# **XAUI TX/RX Jitter Specifications**

**Based on IEEE 802.3ae Draft 3.1**

**Howard Baumer, Jurgen van Engelen  
Broadcom Corp.**

July 26, 2001

# TX Eye Far-end (Absolute)

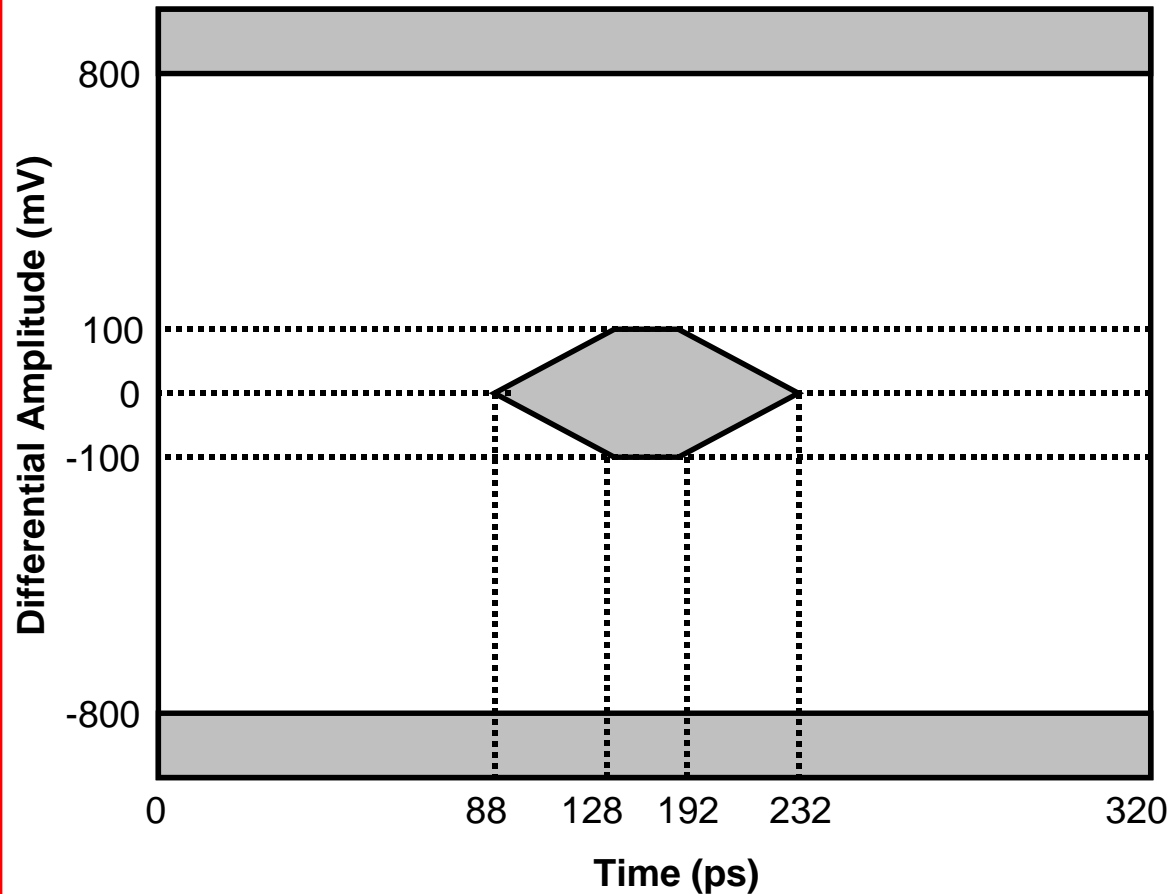
- 200mV to 1600mV peak-to-peak differential
- 0.55UI jitter
- Changed compared to IEEE Draft 3.0!

# TX Eye Far-end (Normalized)

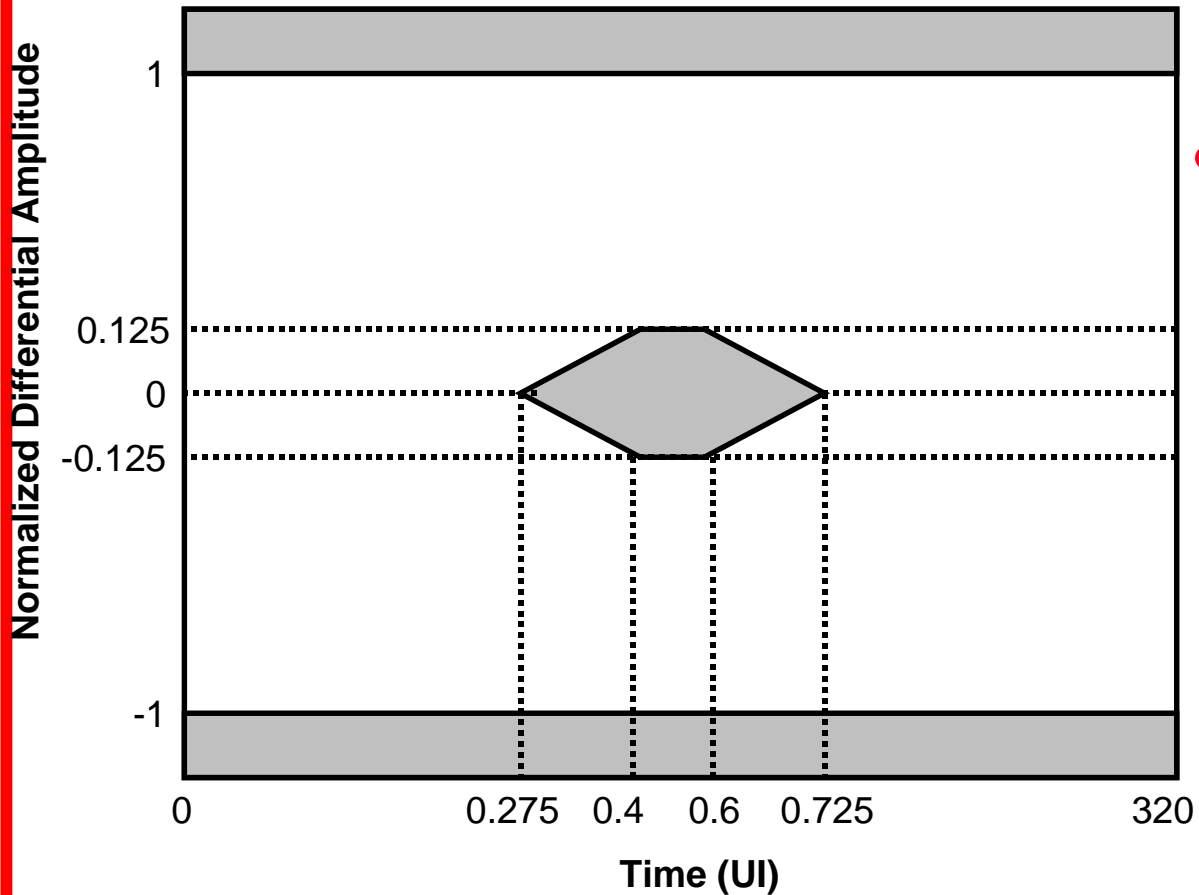
- Full scale amplitude refers to 800mV
- 1UI = 320ps
- Changed compared to IEEE Draft 3.0!

# Typical Jitter Tolerance Set-Up

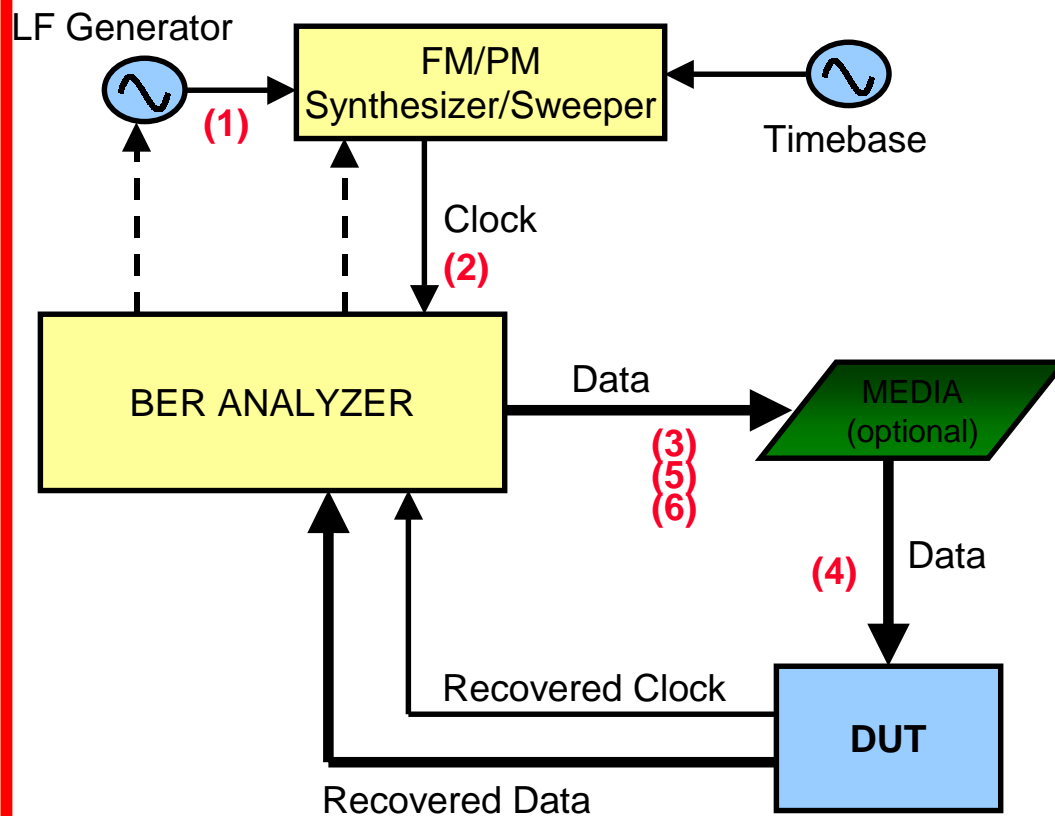
- **How to introduce RJ?**

- Add noise at synthesizer (1)
- Add noise at BERT clock (2)
- Add noise before media (3)
- Add noise after media (4)
- Variable delay line (5)
- Cascaded limiting amps with additive noise (6)

# Problems with RJ testing

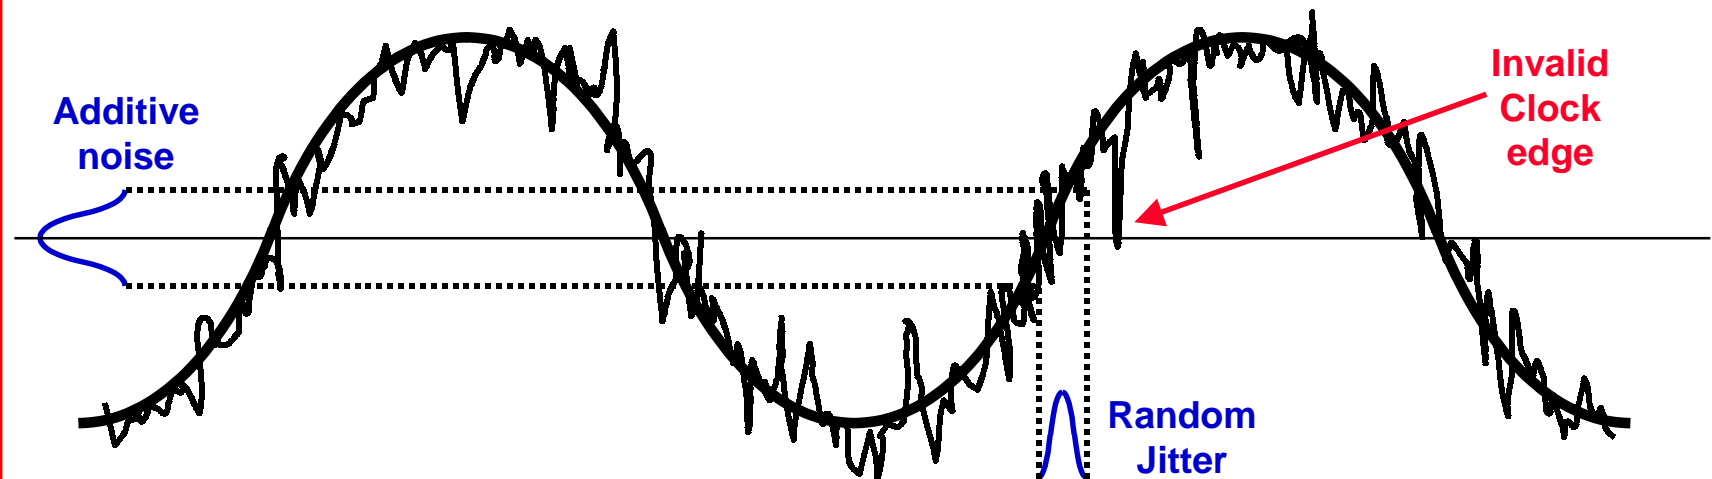
- **(1) Adding noise at synthesizer**
  - Ideal solution: Phase modulate clock with Gaussian noise
  - Problem: No wideband PM synthesizers available. (Noise is 20MHz–2GHz)
- **(2) Adding noise to clock**
  - Additive noise creates jitter at zero-crossings
  - Problem: Additive noise can cause unintended zero-crossings / clock edges

# Problems with RJ testing

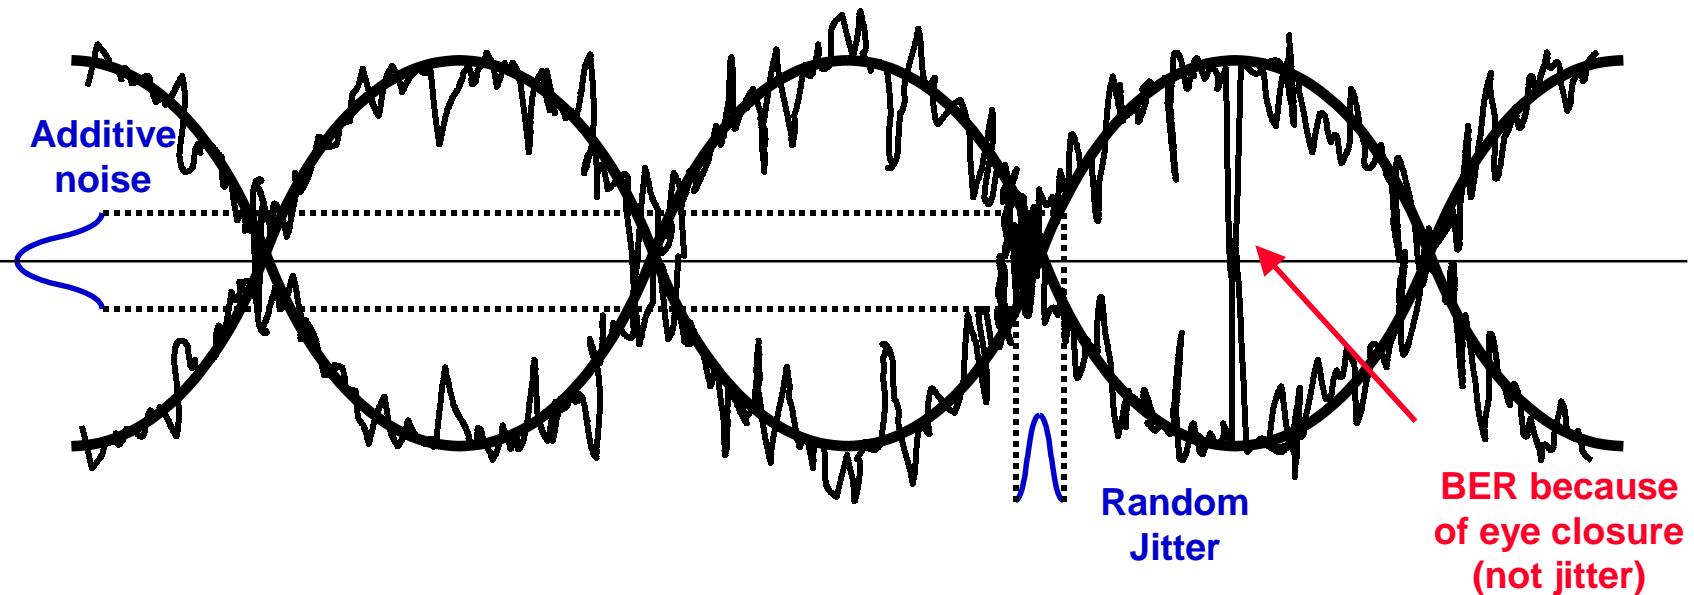
- Additive noise closes vertical eye too!
- Similar to (2)
- There is a finite probability that the noise causes an error at center of the eye

# Problems with RJ testing

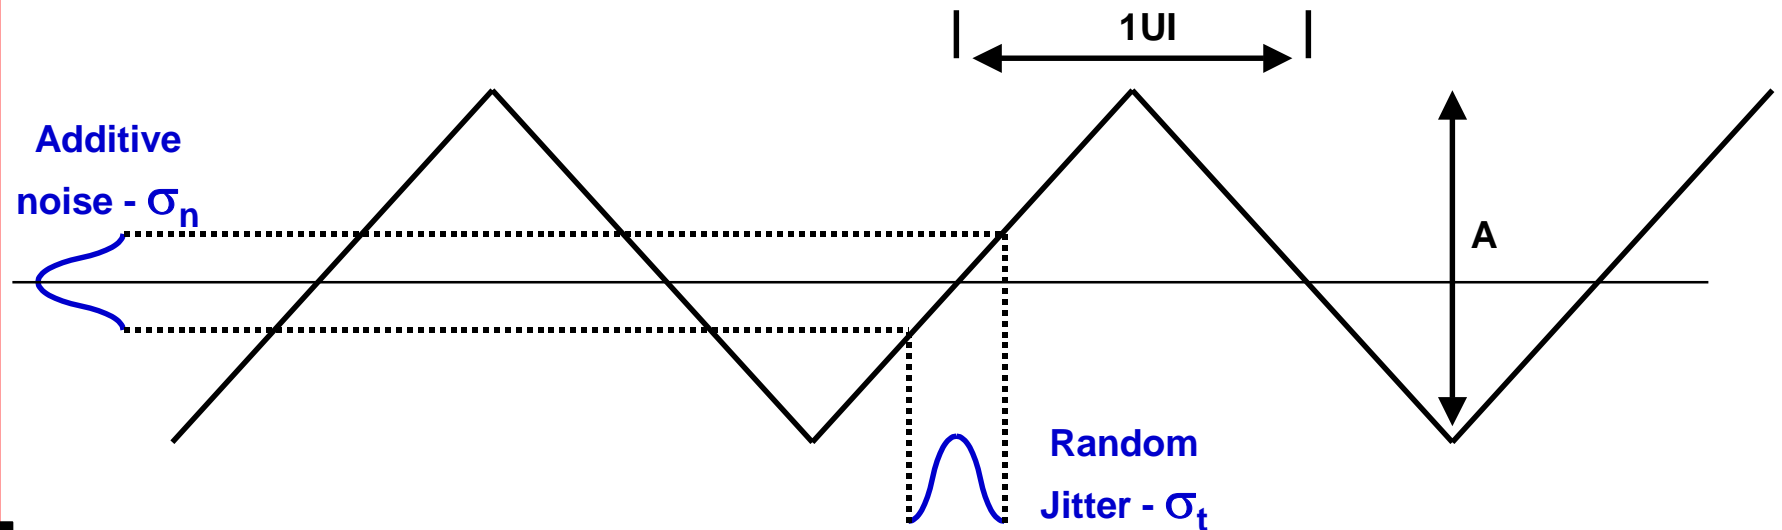
- Use ideal triangular wave (optimal)
- The relation between noise and jitter is:  $\sigma_t = 1UI/A * \sigma_n$
- For 40mUI rms jitter, you need 0.04\*A rms noise.
- The probability of an error due to jitter or due to eye closure is the same!
- For sinewave / pulse signals the probability due to eye closure increases drastically. Because the slope increases and more additive noise is needed for the same jitter, or because the peak signal amplitude decreases.
